Addendum #2

Bid Opportunity: 7183-RW-22 - St Andrews Public School - Interior Renovations

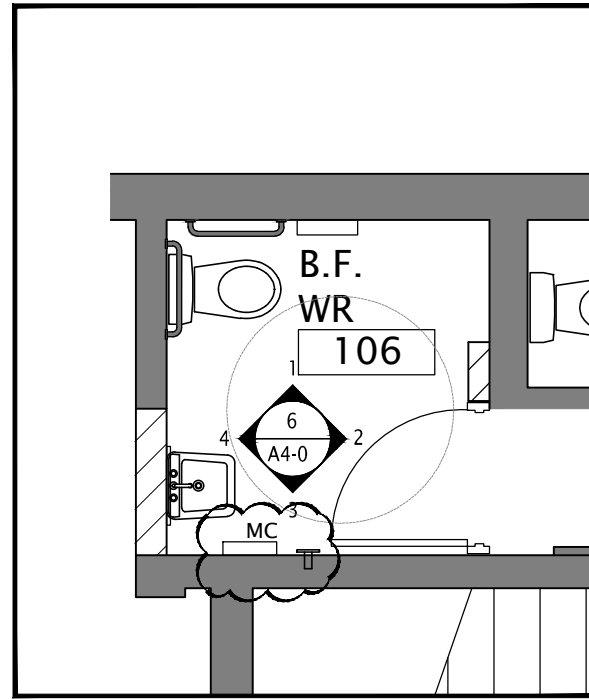
The existing floor in corridor 801 is very uneven and will require extensive preparation for flooring installation. Since this is very difficult to assess at the bid stage can an allowance be provided to level and prepare this floor for the new VSF?

Answer 3: In Ex. Corridor include the following floor preparation for installation of new resilient flooring:

Grind entire existing concrete floor slab, rout and fill with epoxy existing cracks and apply skim coat and leveler to provide a smooth and level substrate for application of resilient flooring.

At the door openings from washrooms to corridor, the new porcelain tile flooring should finish level with the new sheet flooring in the corridor.

ISSUED FOR:	REVISID PLANS AND ELEVATIONS	DATE:	FEB. 2022	SCALE:	1:50
DRAWING NAME:	REVISID PLANS AND ELEVATIONS	DRAWN:	D.T.	PROJECT NO.:	A20002.6
PROJECT NAME:	ST. ANDREW'S PUBLIC SCHOOL	CHECKED:	B.F.	DWC NO.:	AD-01
ARCHITECT:	Kingsland + ARCHITECTS INC.	REV.:

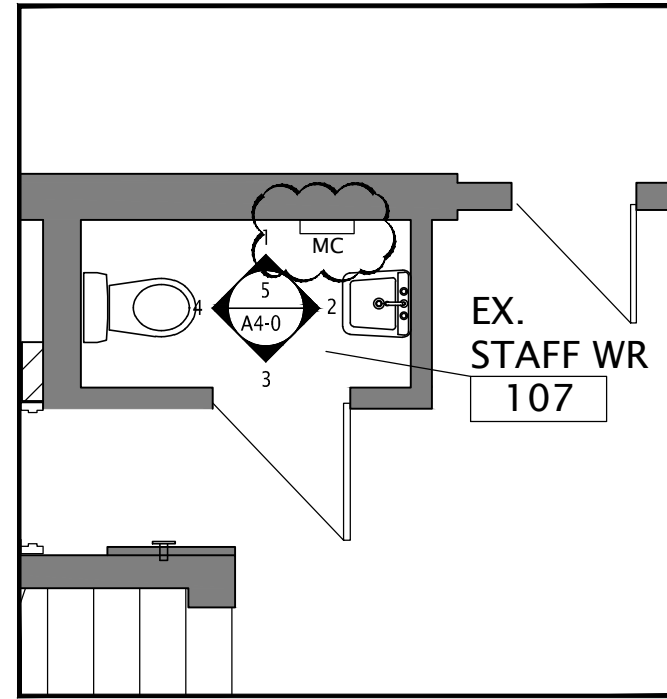
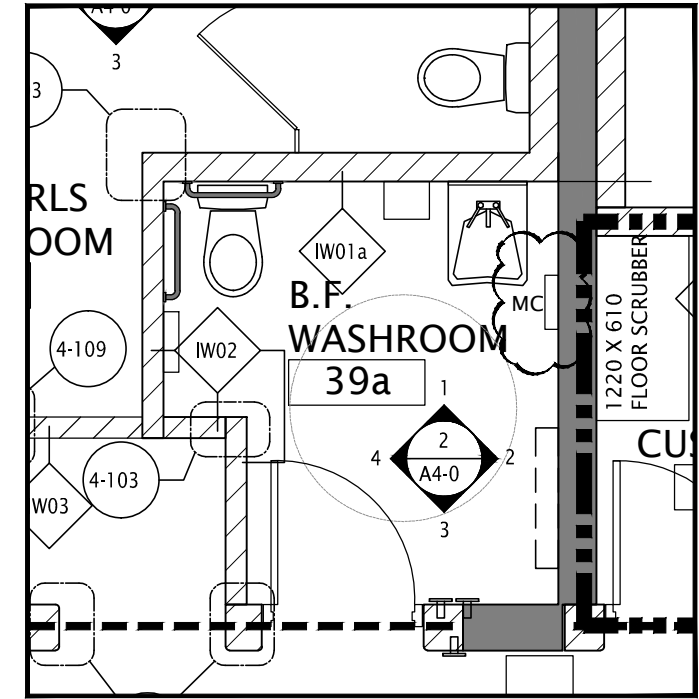
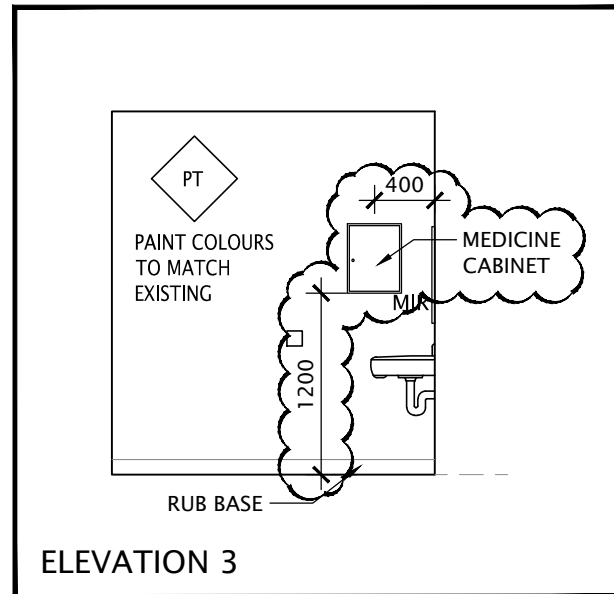
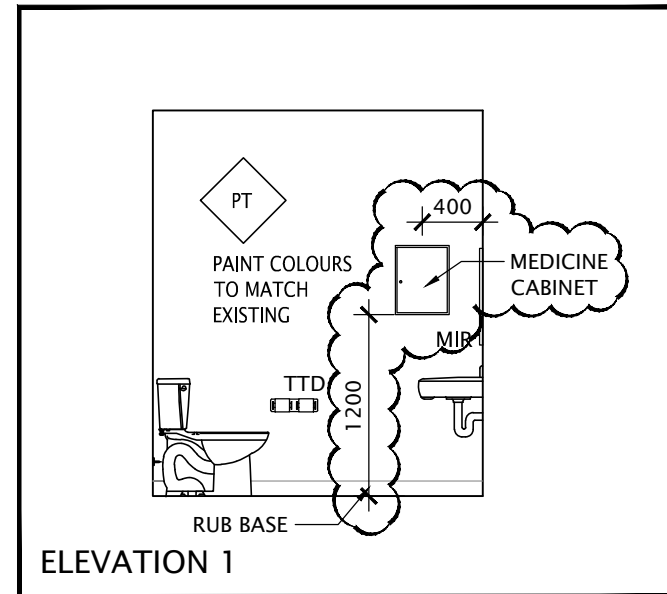
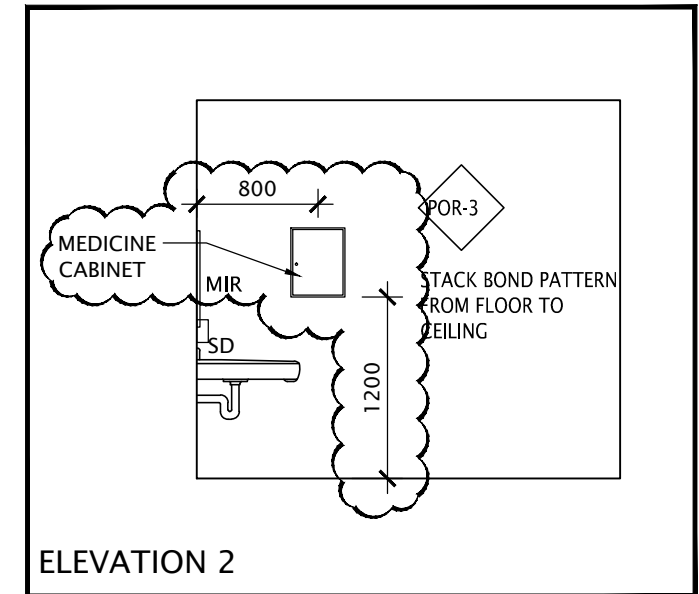
- Refer to attached drawing AD-01 for additional new medicine cabinets in Barrier Free Washroom 39a, New Staff Washroom 106 and Existing Staff Washroom 107.
- Refer to attached drawing AD-02 – New slab required when wall is removed.

- Refer to Section 10800 of the specifications / 3.3 Schedules / .1 and add the following to list of accessories in Barrier Free Washroom 39a, New Staff Washroom 106 and Existing Staff Washroom 107:
 - Global Industrial Stainless Steel Medical Cabinet. 14"x 17" x 3" complete with double key locks

NOTE:
PROVIDE GLOBAL INDUSTRIAL STAINLESS STEEL MEDICINE CABINET
14"X17"X3" COMPLETE WITH DOUBLE KEY LOCKS

ISSUED FOR:  KINGSLAND + ARCHITECTS INC 219 Dufferin Street, Suite 308b Toronto, Ontario M6K 3J1 ph. 416.203.7799 fax. 416.203.7763	DRAWING NAME: CONCRETE SLAB CLARIFICATION	DATE: FEB. 2022	SCALE: 1:50
	PROJECT NAME: ST. ANDREW'S PUBLIC SCHOOL	DRAWN: D.T.	PROJECT NO.: A20002.6
		CHECKED: B.F.	REV.

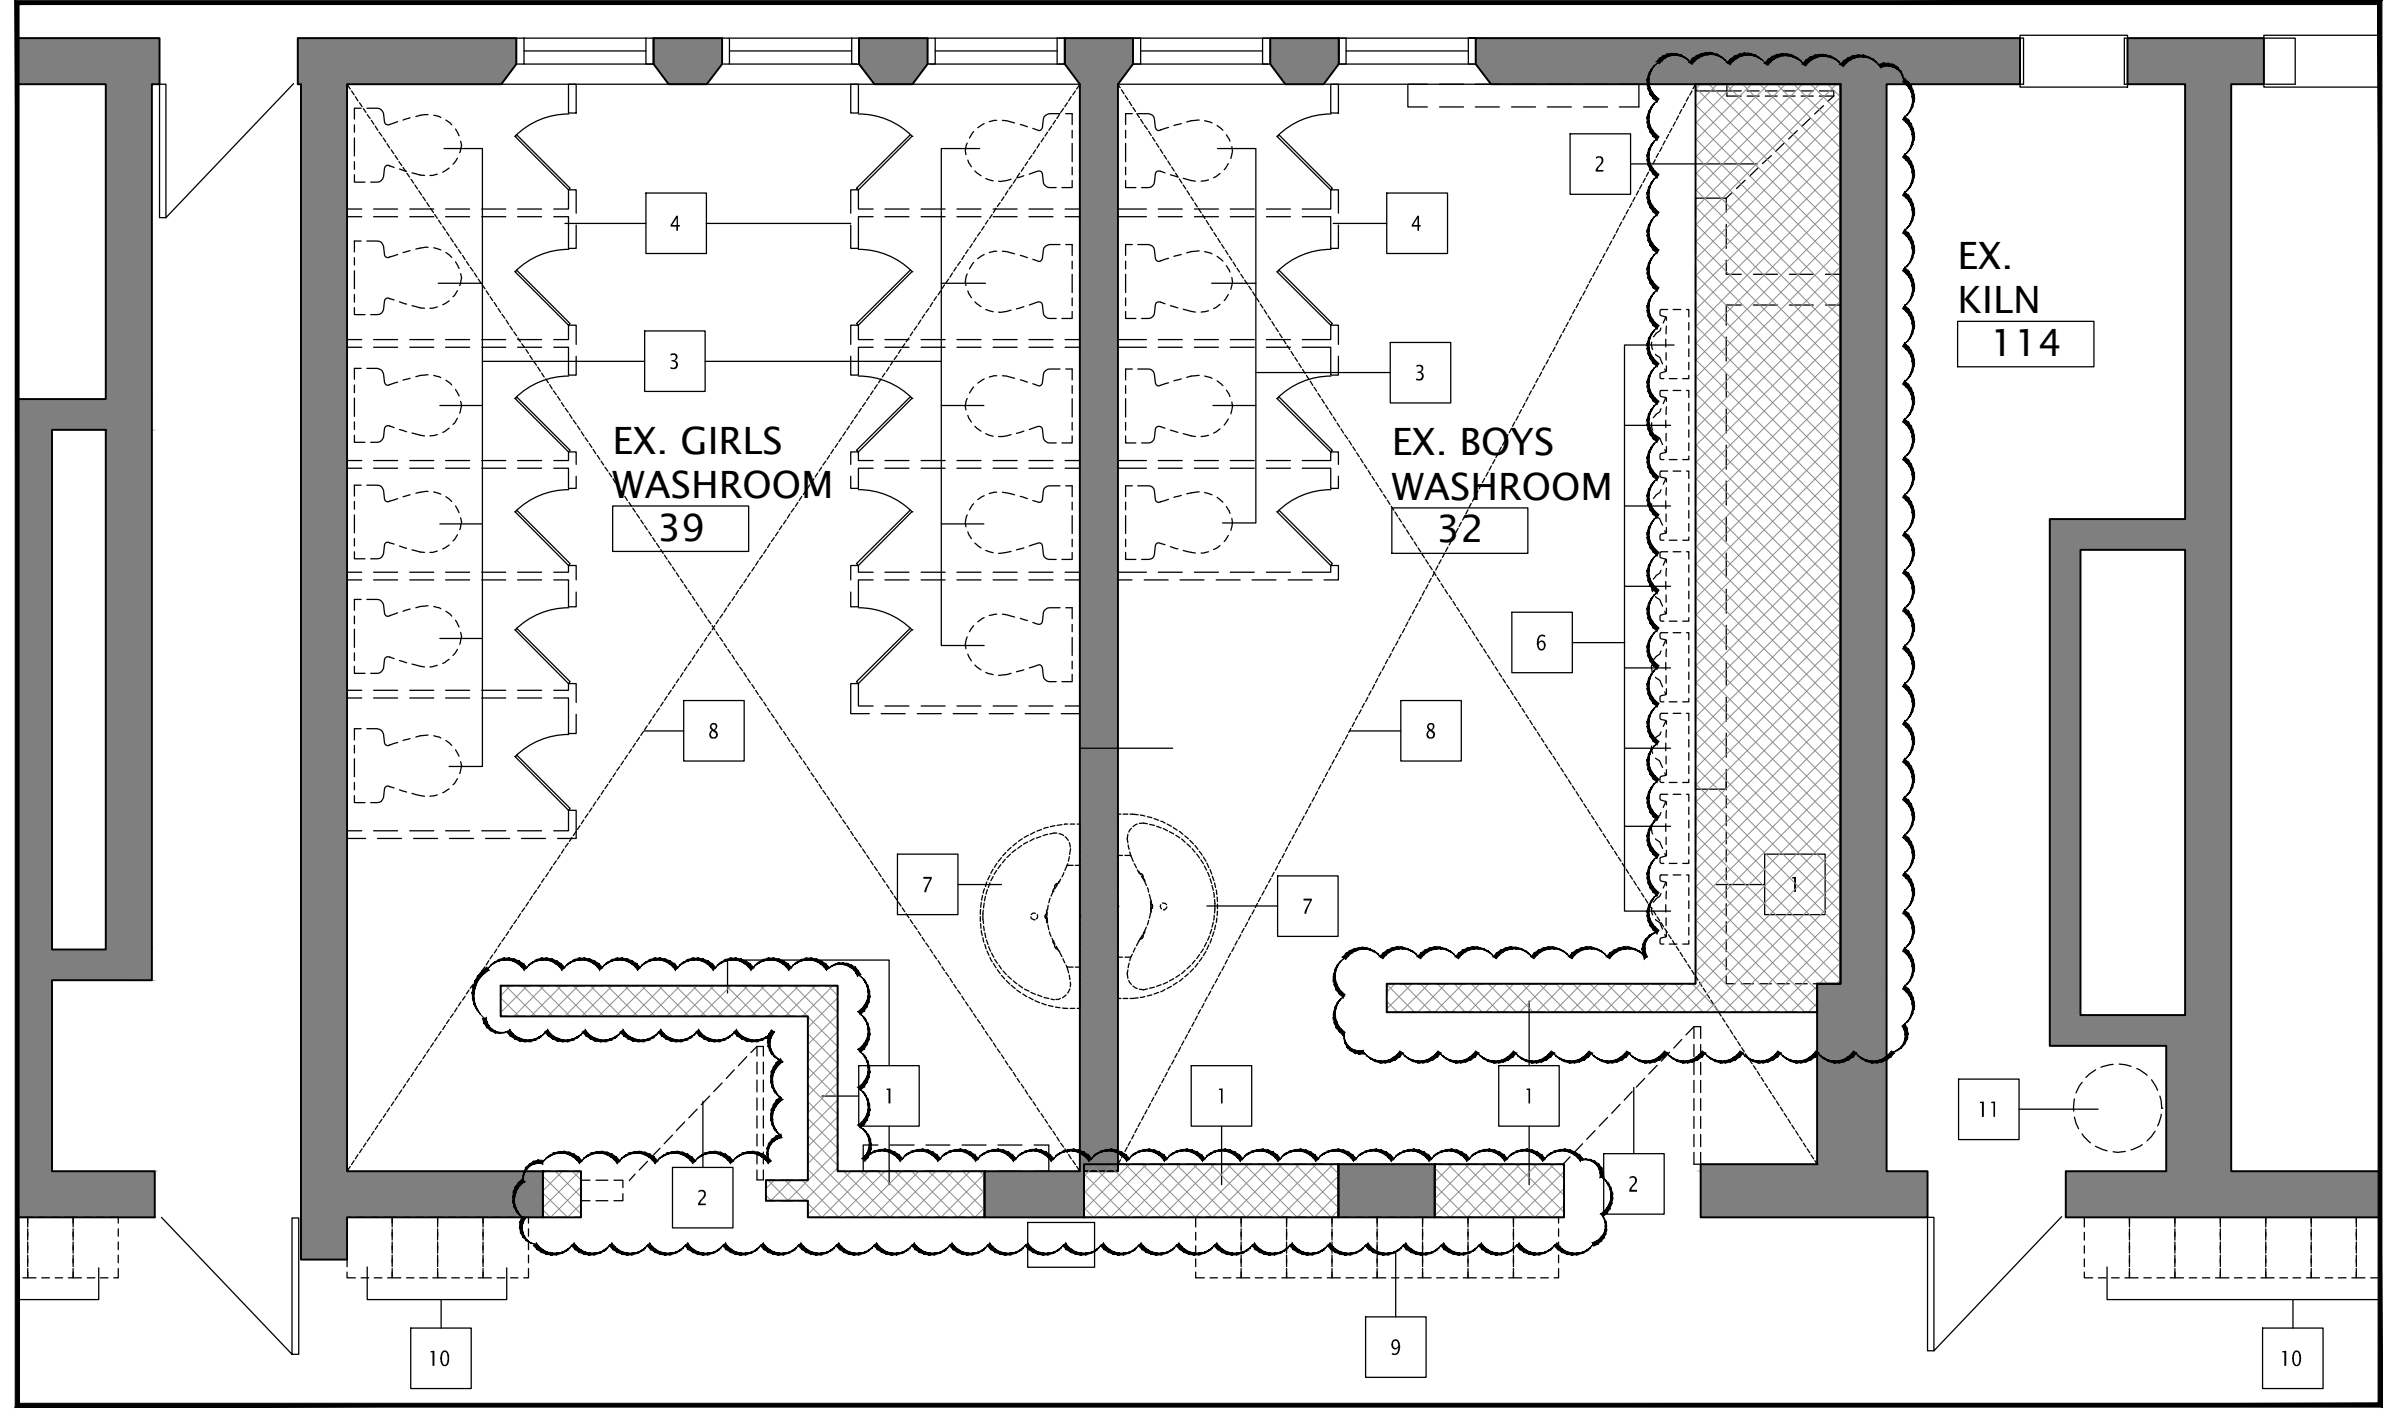
Please confirm the extent of concrete slab on grade removal and replacement in the washrooms being renovated.

Answer 1: Refer to attached drawing AD-02 and mechanical drawings for existing slabs sawcut for trenching:

Provide minimum 10M x 350 mm long steel dowels spaced minimum 400 mm o.c and set into epoxy compound.

Also, at new door openings to corridor through existing bearing wall, remove top course of existing foundation wall below floor level and provide new slab.

- NOTES:
1. PROVIDE NEW SLAB WHEN EXISTING WALLS TO BE REMOVED
 2. AT DOOR OPENINGS TO CORRIDOR THROUGH EXISTING BEARING WALL REMOVE TOP COURSE OF EXISTING FOUNDATION WALL BELOW LEVEL AND PROVIDE NEW SLAB AS REQUIRED
 3. PROVIDE MINIMUM 10M X 350mm LONG STEEL DOWELS SPACED MINIMUM 400mm O.C. AND SET INTO EPOXY COMPOUND .
 3. MINIMUM THICKNESS OF NEW CONCRETE SLABS TO BE 150mm
